**LAND NORTH OF ORTON ROAD,
WARTON,
WARWICKSHIRE**

**STAGE 1
ROAD SAFETY AUDIT REPORT**

Project: Land North of Orton Road, Warton, Warwickshire
Proposed Highway Works

RKS Associates Ref: VRP1982 - RSA 1

Appendix A

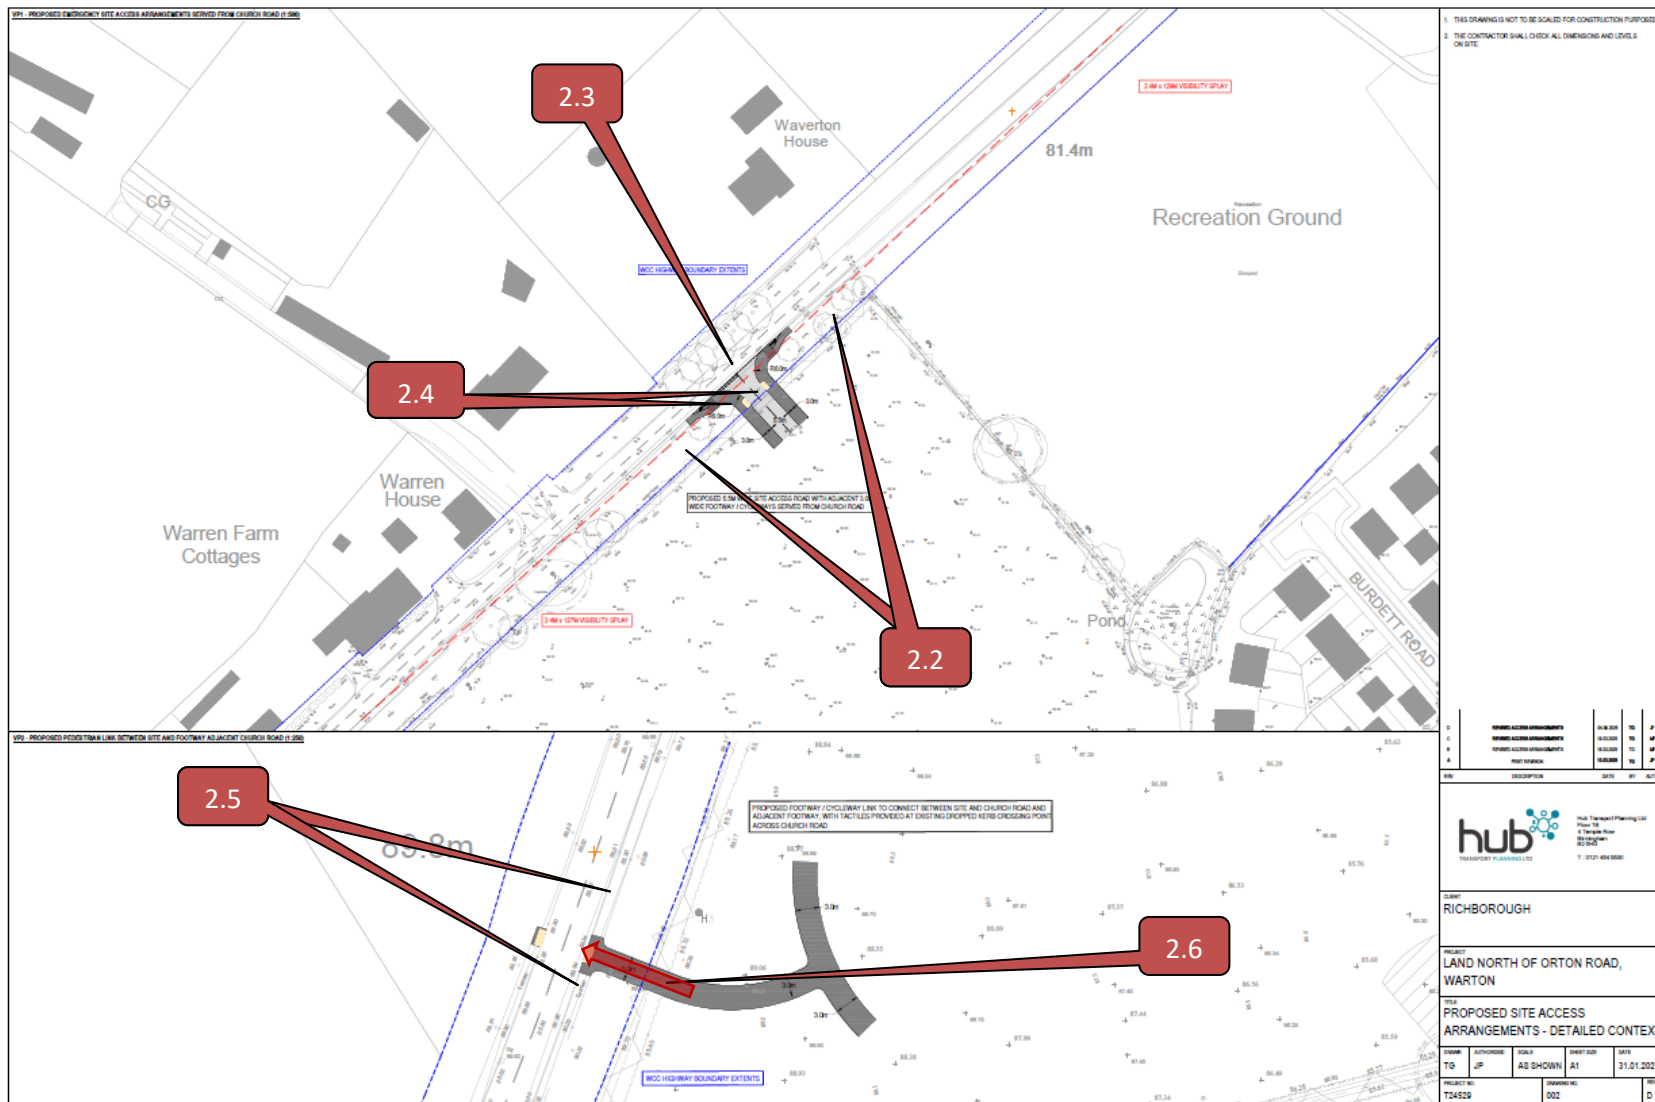
Summary: Potential collisions due to standing water or service covers

No details have been provided in respect of surface water drainage or other services, it is therefore not possible to ascertain whether there will be any safety implications. The absence of surface water drainage may result in the collection of surface water on the local highway, which could increase the risk of loss of control collisions.

Ensure that surface water drainage is provided to mitigate the risk of collection of surface water on the carriageway.

Summary: Potential risk of collisions associated with obstruction in visibility

Visibility splays to and from the proposed development access have been provided and accord with highway standards. However, there is concern that vegetation behind and overhanging the visibility splays may over time restrict visibility for motorists accessing the development. Poor visibility may increase the risk of turning collisions between vehicles accessing the development and traffic travelling along Church Road.

Ensure that vegetation behind and overhanging the visibility splays should be cut back and regularly maintained or replaced with a low-level variety to ensure that it does not restrict visibility to and from the proposed development access.

Summary: Potential vehicle collisions due to inadequate road space or visibility

It is noted that the proposed site access road has been designed in accordance with Warwickshire County Council Design Guide. However, vehicle swept path plots associated with refuse vehicles negotiating the development access indicate that the refuse vehicle will overrun the opposing carriageway of the access road to complete the turning manoeuvre. Insufficient carriageway space may increase the risk of collision between vehicles entering and exiting the development access simultaneously or may encourage large vehicles to overrun the footway putting pedestrians waiting on the footway of being struck turning vehicles.

Review the layout, it may be necessary to modify the layout of development access to minimise the risk of collisions associated with vehicles overrunning the opposing traffic lane/footway. Alternatively ensure that forward visibility is provided at development access to enable motorists approaching the junction to observe on-coming traffic.

Summary: Potential risk of non-motorised users struck by turning traffic

No details relating to the visibility splays to and from the tactile landings at the proposed uncontrolled crossing facilities across the proposed development access have been provided. There is concern that visibility to and from the proposed tactile landings may be compromised by vegetation and as a result poor visibility may lead to non-motorised users entering the carriageway to observe oncoming traffic leading to an increased risk of them being struck by vehicles.

Ensure visibility splays to and from the tactile landings at the proposed uncontrolled crossing facility across the development access are provided, any vegetation within/behind the visibility splays should be cut back and regularly maintained, alternatively move the crossing facilities closer towards Church Road.

Summary: Potential risk of pedestrian/cycle collisions associated with poor visibility

No details relating to the visibility splays to and from the tactile landings at the proposed uncontrolled crossing facility across Church Road to the north of Orton Road have been provided. Observations during the site inspection noted that vegetation along Church Road on its approach to the crossing may compromise visibility to and from the tactile landings, this may to users of the crossing to step out onto the carriageway to observe oncoming traffic leading to an increased risk of them being struck by passing vehicles.

Ensure visibility splays to and from the tactile landings of the proposed uncontrolled crossing facility across Church Road provided, any vegetation within/behind the visibility splays that restrict visibility should be cut back and regularly maintained.

Summary: Potential risk of collisions associated with users of the crossing inadvertently entering carriageway

The alignment of the footway link from the development to the proposed uncontrolled crossing facility across Church Road to the north of Orton Road guides pedestrian users directly onto the carriageway. Consequently, there is a greater risk that users of the crossing facility may fail to stop and observe on-coming traffic before proceeding to cross the carriageway. This may result in a greater risk of pedestrians inadvertently entering the carriageway where the risk of them being struck by passing vehicles will be greater.

Amend the arrangement of the footway link from the development connection to the proposed uncontrolled crossing facility across Church Road to the north of Orton Road to mitigate the risk of pedestrians inadvertently entering the carriageway directly from the footpath.

Issue N°	RSA Problem	RSA Recommendation	Design Organisation Response	Overseeing Organisation Response	Agreed RSA Action
2.1	No details have been provided in respect of surface water drainage or other services, it is therefore not possible to ascertain whether there will be any safety implications. The absence of surface water drainage may result in the collection of surface water on the local highway, which could increase the risk of loss of control collisions.	Ensure that surface water drainage is provided to mitigate the risk of collection of surface water on the carriageway.	Agree - surface water drainage strategy will be provided at the detailed design stage post-planning.

2.2	Visibility splays to and from the proposed development access have been provided and accord with highway standards. However, there is concern that vegetation behind and overhanging the visibility splays may over time restrict visibility for motorists accessing the development. Poor visibility may increase the risk of turning collisions between vehicles accessing the development and traffic travelling along Church Road.	Ensure that vegetation behind and overhanging the visibility splays should be cut back and regularly maintained or replaced with a low-level variety to ensure that it does not restrict visibility to and from the proposed development access.	Agree – vegetation is to be trimmed back and maintained to prevent any obstructions to the visibility splays shown in Drawings T24529 001 - 003

2.3	It is noted that the proposed site access road has been designed in accordance with Warwickshire County Council Design Guide. However, vehicle swept path plots associated with refuse vehicles negotiating the development access indicate that the refuse vehicle will overrun the opposing carriageway of the access road to complete the turning manoeuvre. Insufficient carriageway space may increase the risk of collision between vehicles entering and exiting the development access simultaneously or may encourage large vehicles to overrun the footway putting pedestrians waiting on the footway of being struck turning vehicles.	Review the layout, it may be necessary to modify the layout of development access to minimise the risk of collisions associated with vehicles overrunning the opposing traffic lane/footway. Alternatively ensure that forward visibility is provided at development access to enable motorists approaching the junction to observe on-coming traffic.	Partially Agree – The site access road has been designed in accordance with the Warwickshire Design Guide and is able to accommodate the WCC Refuse Vehicle. Although this vehicle does require to utilise the majority of the roadspace within the junction when turning into / out of the site, this movement is to occur once per week. Drawing T24529.003 has been revised to Revision D to demonstrate that 25m forward visibility splays can be provided between a refuse vehicle at the site access and car on Church Road where two-way movements can be accommodated.

Drawing T24529.002 has been revised to Revision E to include forward visibility splays based on the design speeds of Church Road.		
2.4	No details relating to the visibility splays to and from the tactile landings at the proposed uncontrolled crossing facilities across the proposed development access have been provided. There is concern that visibility to and from the proposed tactile landings may be compromised by vegetation and as a result poor visibility may lead to non-motorised users entering the carriageway to observe oncoming traffic leading to an increased risk of them being struck by vehicles.	Ensure visibility splays to and from the tactile landings at the proposed uncontrolled crossing facility across the development access are provided, any vegetation within/behind the visibility splays should be cut back and regularly maintained, alternatively move the crossing facilities closer towards Church Road.	Agree - Drawing T24529.002 has been revised to Revision E to include 2m x 17m pedestrian visibility splays each side of the proposed crossing point across the site access road, based on 15mph design speeds in accordance with MfS Guidance. These pedestrian visibility splays will be kept clear of any obstructions, with any overgrown hedge to be trimmed back and maintained behind the splays.

2.5	No details relating to the visibility splays to and from the tactile landings at the proposed uncontrolled crossing facility across Church Road to the north of Orton Road have been provided. Observations during the site inspection noted that vegetation along Church Road on its approach to the crossing may compromise visibility to and from the tactile landings, this may to users of the crossing to step out onto the carriageway to observe oncoming traffic leading to an increased risk of them being struck by passing vehicles.	Ensure visibility splays to and from the tactile landings of the proposed uncontrolled crossing facility across Church Road provided, any vegetation within/behind the visibility splays that restrict visibility should be cut back and regularly maintained.	Agree - Drawing T24529.002 has been revised to Revision E to include 2m / back of footway x 43m pedestrian visibility splays to the south and 59m visibility splays to the north based on 30mph and 37mph speeds to the south and north respectively in accordance with MfS Guidance. Given the location of the crossing points, these vehicular speeds are not expected to be exceeded given the short distance from the Church Road / Orton Road junction. These pedestrian visibility splays will be kept clear of any obstructions, with any overgrown hedge to be trimmed back and maintained behind the splays.

2..6	The alignment of the footway link from the development to the proposed uncontrolled crossing facility across Church Road to the north of Orton Road guides pedestrian users directly onto the carriageway. Consequently, there is a greater risk that users of the crossing facility may fail to stop and observe on-coming traffic before proceeding to cross the carriageway. This may result in a greater risk of pedestrians inadvertently entering the carriageway where the risk of them being struck by passing vehicles will be greater.	Amend the arrangement of the footway link from the development connection to the proposed uncontrolled crossing facility across Church Road to the north of Orton Road to mitigate the risk of pedestrians inadvertently entering the carriageway directly from the footpath.	Partially Agree - Drawing T24529.002 has been revised to Revision F to show a cycle barrier approximately 8m east of the crossing point to reduce pedestrian / cycle speeds on approach to Church Road. This, along with the implementation of tactiles each side of the existing crossing point across Church Road will ensure all pedestrians and cyclists are able to identify the crossing point on approach and slow down accordingly.
